PERFORMANCE SPECIFICATION SHEET

SEMICONDUCTOR DEVICE, DIODE, SILICON,
 SCHOTTKY BARRIER, FAST RECOVERY,
 TYPE 1N6391, JAN, JANTX, JANTXV, JANS, AND JANHC

This amendment forms a part of MIL-PRF-19500/553A, dated 27 June 1997 and is approved for use by all Departments and Agencies of the Department of Defense.

Figure 1. Physical dimensions (similar to DO-41).

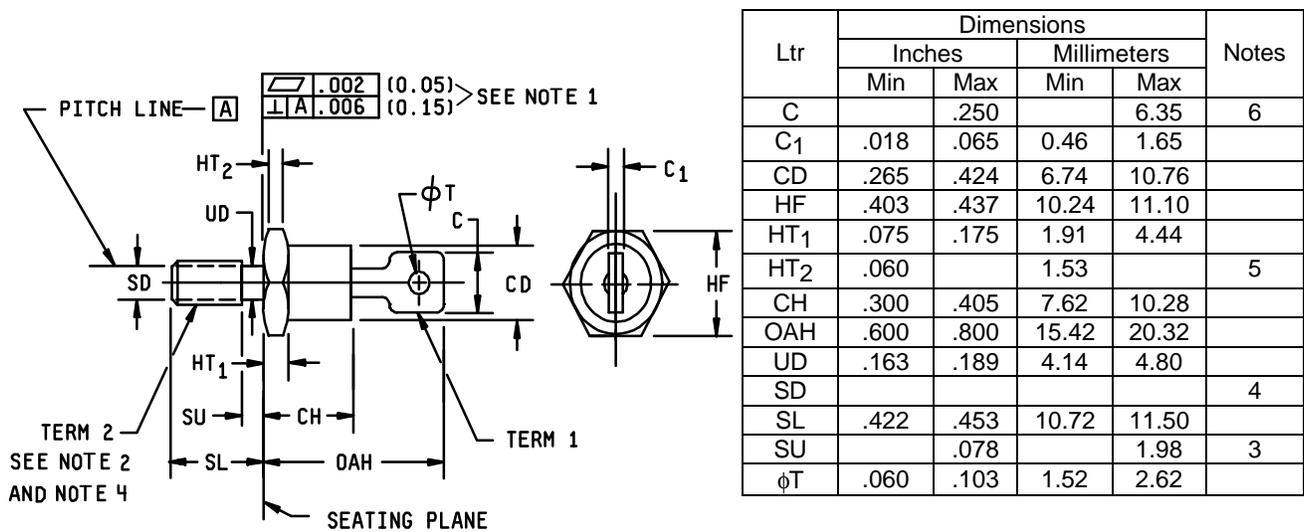
Figure 1 Physical dimensions. Delete in its entirety and substitute:

- Dimensions are in inches, metric equivalents are given for general information only.
- Units must not be damaged by torque of 15 inch-pounds applied to .10-32 UNF-2B nut assembled on thread.
- Length of incomplete or undercut threads - SU.
- Maximum pitch diameter of plated threads shall be basic pitch diameter .1697 inch (4.31 mm) reference (FED-STD-H28, Screw-Thread Standards for Federal Services).
- A chamfer or undercut on one or both ends of the hex portion is optional; minimum base diameter at seating plane .403 inch (10.24 mm).
- The angular orientation and peripheral configuration of terminal 1 is undefined, however, the major surfaces over dimensions C and C₁ shall be flat.
- Dimension CD can not exceed dimension HF
